ADDENDUM

07TS0163

Andrew Gibb
(Queensgate)

STAFF'S
REQUEST ANALYSIS
AND
RECOMMENDATION

QUEENSGATE SUBDIVISION
TENTATIVE
MIDDLETON & MATOCHA DISTRICT
CHESTERFIELD COUNTY
VIRGINIA

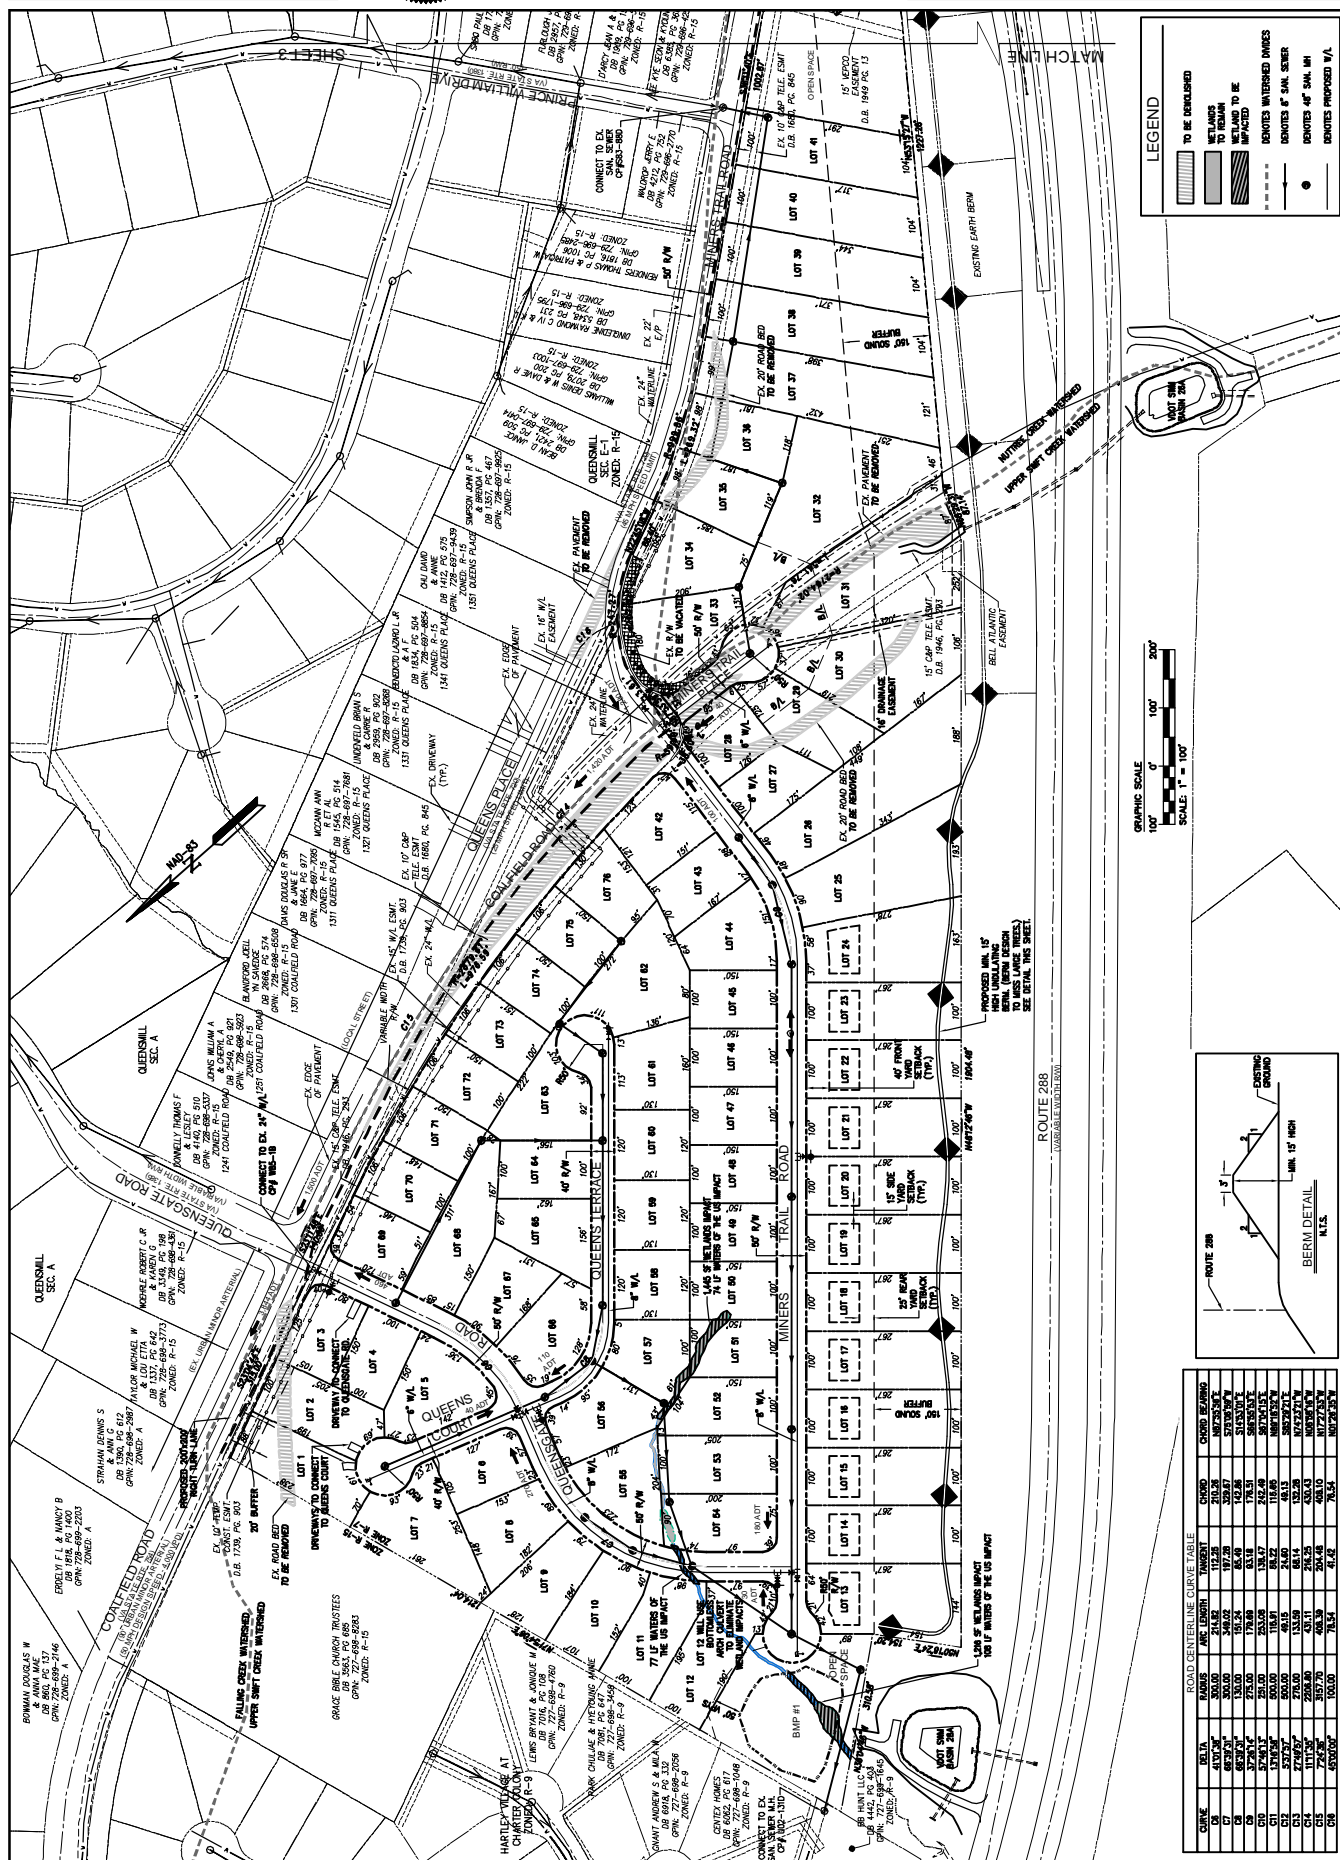
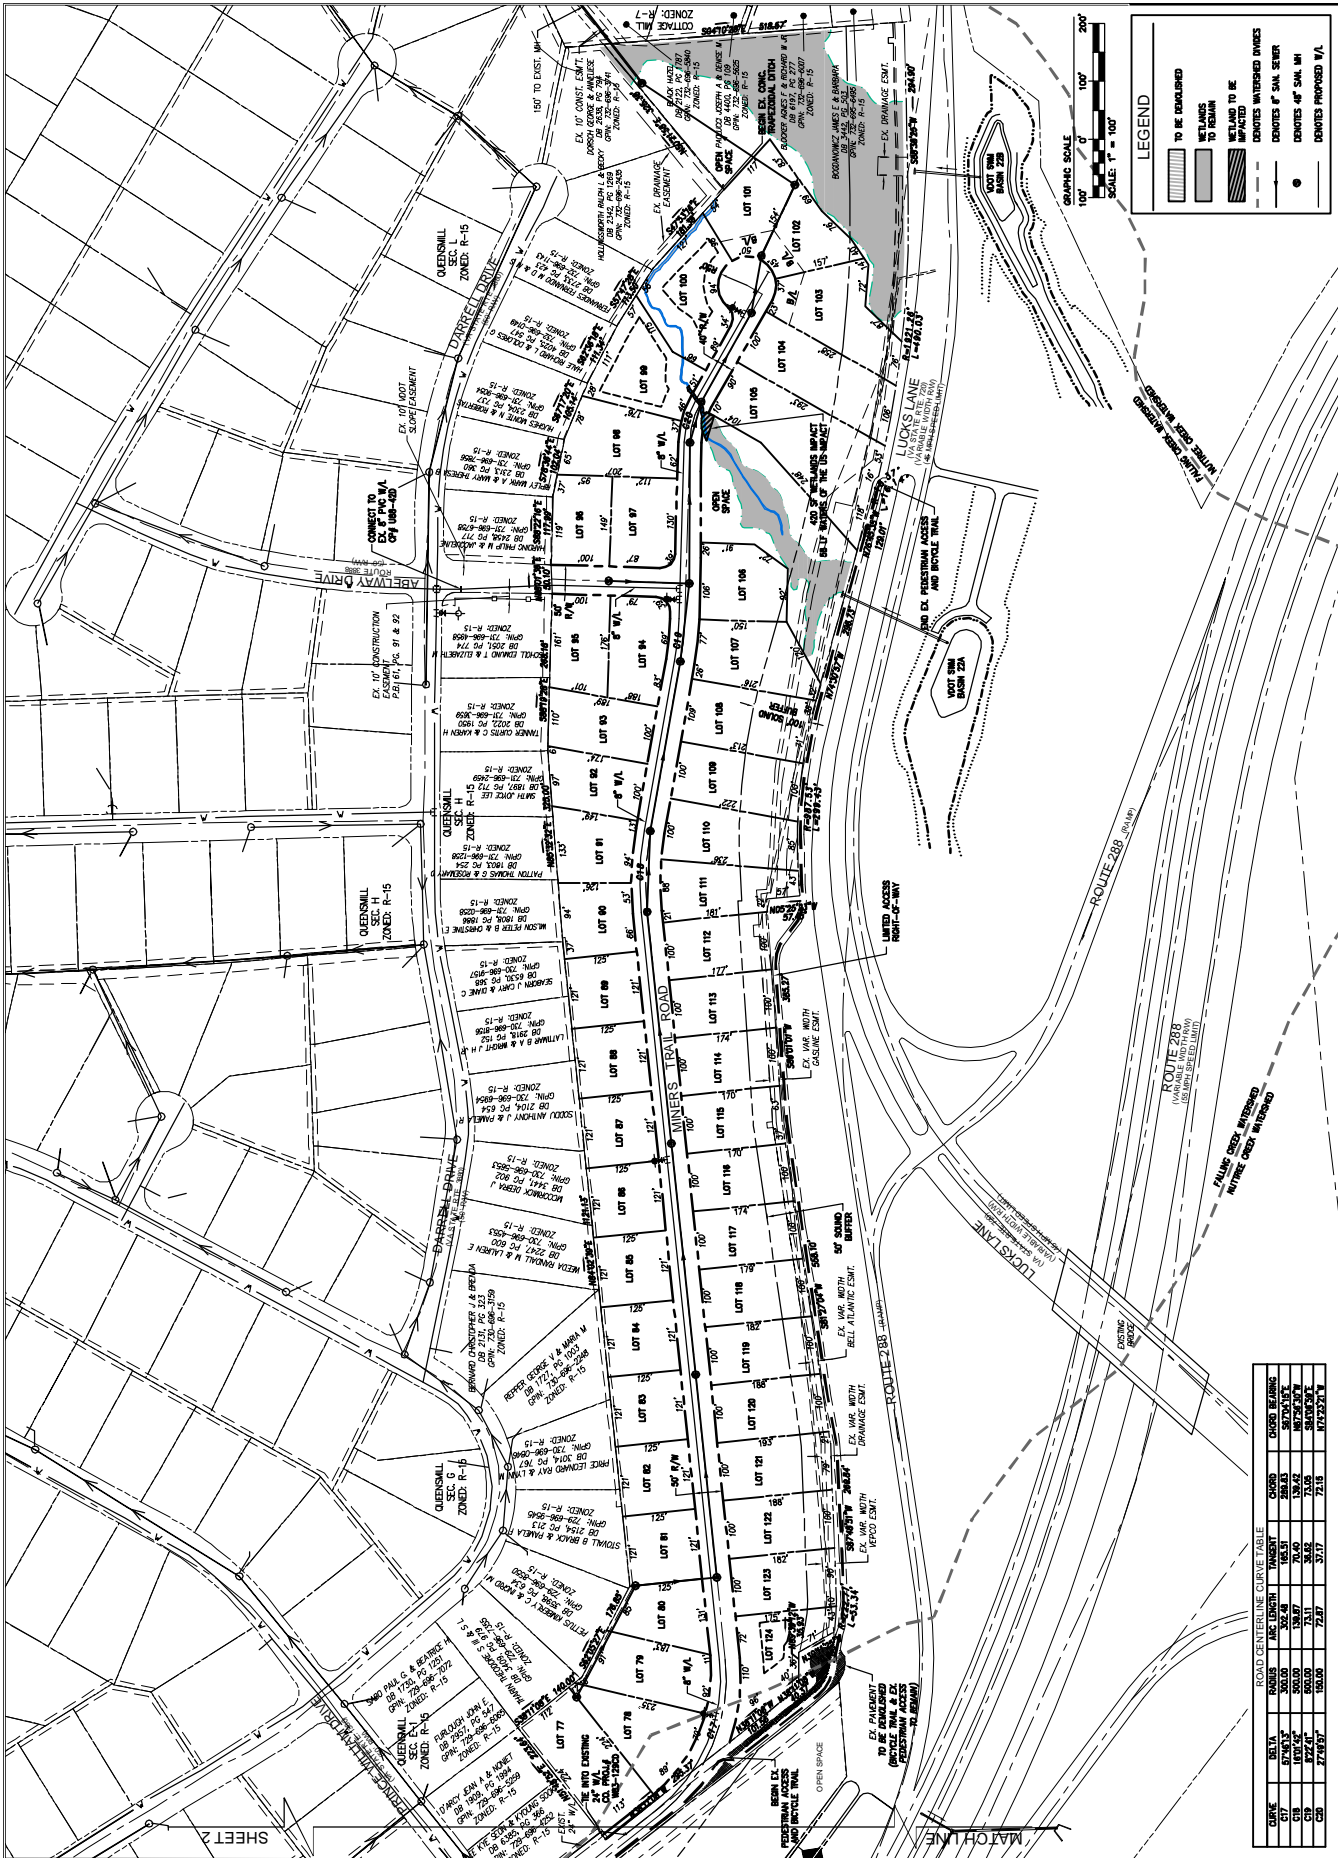
18. Unless otherwise directed by the Environmental Engineering Department, the storm drainage design for the project will direct no storm drainage from road rights of way into the wetlands at the rear of lots 102 and 103. (EE)

19. Unless otherwise directed by the Environmental Engineering Department, the storage volume created by the road embankment of Miners Trail Road downstream of the wetlands in lots 111 and 112 shall be utilized in the culvert design for the roadway in this location. (EE)

24. If the proposed berm is approved by the Planning Commission, the location of the existing and proposed berm shall be shown on the tentative plan. The specific details relative to the design of the berm shall be approved by the Transportation Department at time of construction plan review. (T)
